Application for Certificate of Appropriateness

405 West Cuyler Street, Dalton, GA 30721

Docket No. 85-ARC

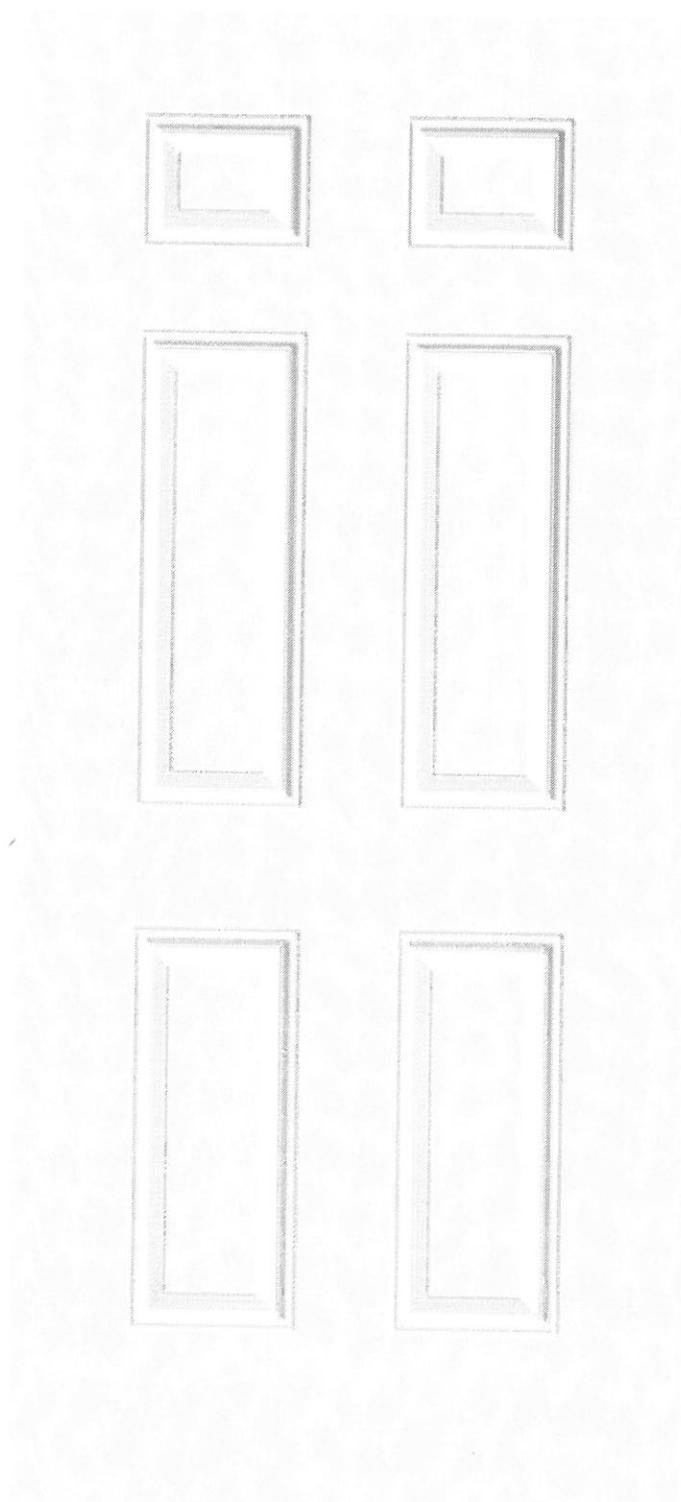
In reviewing your application, unless the existing door is not original and the original door was a standard shaped door, I do not believe the proposed replacement meets the guidelines. If you can provide original photos of the house with a different door, then we may could approve replacement based on the original design.

The application says the existing door is beyond repair and no longer available. I don't know about the condition of the existing door, but I do know that round top entry doors are available. Do you have another proposed door option for consideration?

The door doesn't look to be original. Notice the vinyl siding that covers the brick. Door was originally dimensional door.
